Request for FCC Class II Permissive Change

Request for ISED Class II Permissive Change

FCC ID: AL8-B825

IC: 457A-B825

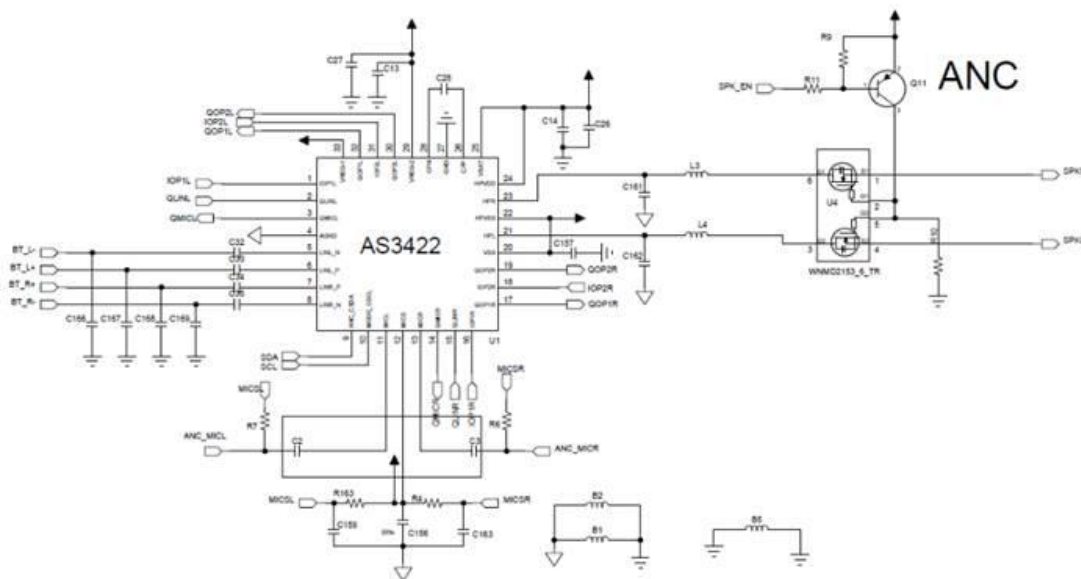
1. Changes are on the ANC area of the schematic. Previous ANC circuit was simpler and looked like the image below:

For 219930-01 U28 was added and U1 was replaced with the new ANC chip, this added additional passive components around this two ICs.
